Title		LIGO Laboratory California Institute of Technology, Massachusetts Institute of Technology		LIGO Date: 9/27/2012 Time: 1:49:14 PM Sheet 1 of 2
Differential to Single Ended Driver				
Size: A	DCC Number: D1100457	Revision: v2	Engineer: R. Abston	
File: C:\msc\csheff@Document\diff_rec(13-10)14-32-58 PM\diff_top_SchDoc

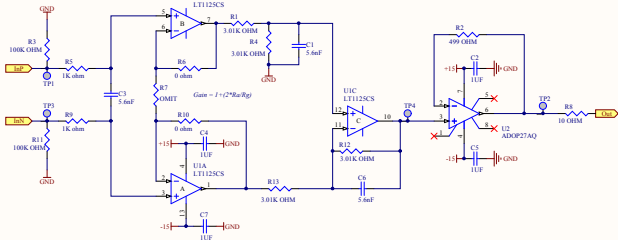
9/27/2012 - Changed R4 and R12 to 3.01K ohm resistors.
Version 1 PCB still used.
